# Royal Randwick Racecourse – Leger Lawn Development (Winx Stand) Modification 2

Design amendments to the Winx Stand and the link bridge  
State Significant Development Modification Assessment  
(SSD 10285 MOD 2)

July 2021

Published by the NSW Department of Planning, Industry and Environment

**Figure 3** | Level 1 floor plan (source: Applicant)

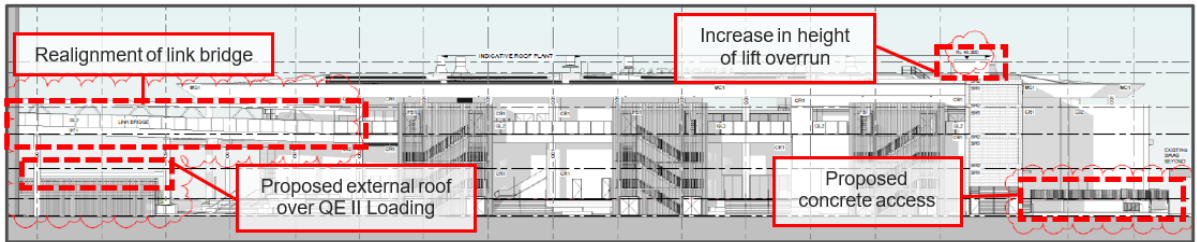
The proposed modification seeks to add an external roof structure above the existing QE II loading dock on the eastern elevation of the Winx Stand. The roof will be positioned between the mezzanine level of the approved building with a maximum height of 4.5 m/ RL 34.5 (**Figure 3**).

The Applicant advised the reason for the additional roof is to provide all-weather shelter and protection for employees of the site using the loading dock and obstruct the view of back-of-house operations from patrons.

The Department considers the proposed roof structure to be acceptable as it is light weight structure, maintains the openness of the loading dock area and would not result in any additional visual impacts or significantly change the bulk or scale of the approved development.

**Figure 6 | Comparison of west elevation: approved plan (above) and proposed modification (below) (source: Applicant)**

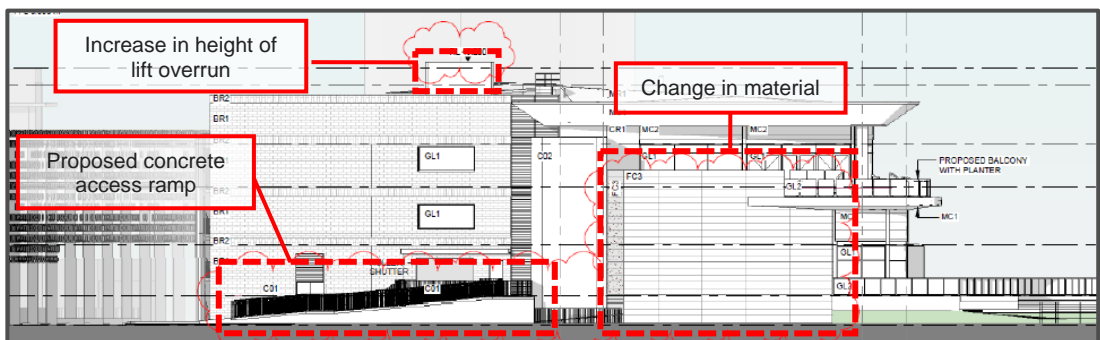
- The modification seeks to change the materiality of the southern portion of the western façade from a 'light grey' cement render to 'urban grey' fibre cement sheeting (as shown in **Figure 6**).

- The Applicant advised the reason for this change is to improve the durability of the façade.
- In the initial application, brickwork was incorporated into the northernmost portion of the western façade following the advice from GANSW. No changes are proposed to the northern portion of the western façade.

- The modification proposes a 20 m (approx.) long concrete access ramp adjacent to the ground floor
-

loading zone on the western elevation (as shown in **Figure 6**).

- The purpose of this amendment is to improve OH&S operations and functionality for employees loading and unloading goods into the building.
- The ramp will be predominantly obscured by the existing Swab building, with 9 m (approx.) visible from beyond Swab building.
- The Department considers the addition of a concrete access ramp on the western elevation to be acceptable as it improves the functionality of the development and would not significantly change the appearance of the approved development.
- The Department therefore concludes the proposed access ramp is acceptable.

- The Department considers the proposed change to the materiality of the western façade to be acceptable as it maintains the integrity and quality of the design of the building.

- The Department therefore concludes the proposed materiality changes to the western façade is acceptable.

**Figure 7 |** Lift overrun height (western elevation): approved plan (left) and proposed modification (right) (source: Applicant)

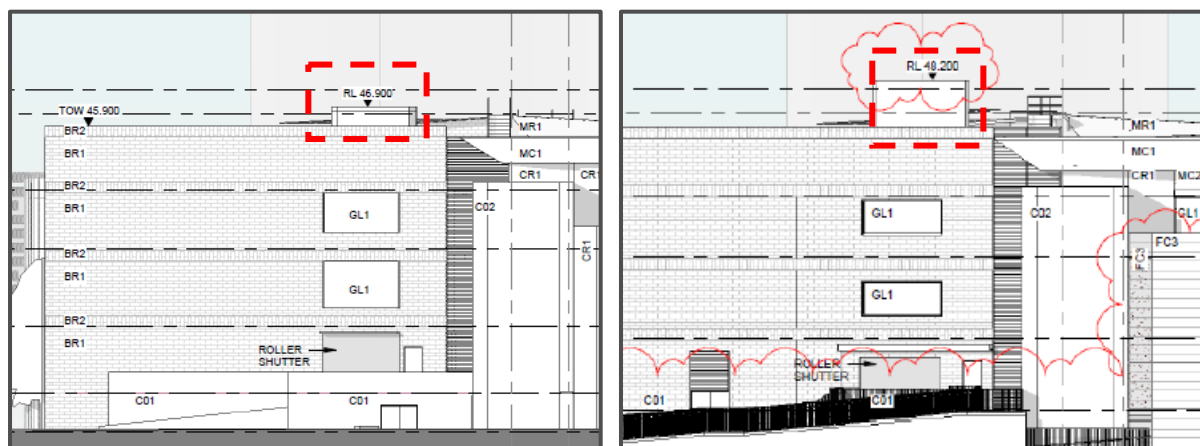
The approved development comprised a two-storey building with an overall maximum building height of 17.75 m (RL 47.75 m). The proposed modification seeks to increase the height of the lift overrun by 1.3 m from RL 46.9 to RL 48.2, which would increase maximum building height by 0.45 m from 17.75 m to 18.2 m (RL 48.2).

The Applicant advised this change was required in response to mechanical services following the detailed design of the loading dock. A comparison of the height difference is shown in **Figure 7** below.

The Department considers the increase in building height to be acceptable as:

- there are no height or floor space controls for the site
- the 0.45 m increase in height is minor as it represents only an increase of 2.5% of the approved building height and would be indiscernible from the surrounding area
- it will not result in any additional overshadowing, privacy or view loss impacts
- the QEII Grandstand, multi-deck car park and existing vegetation will continue to screen the development from surrounding residences.

The Department therefore concludes the proposed increase in height is acceptable.
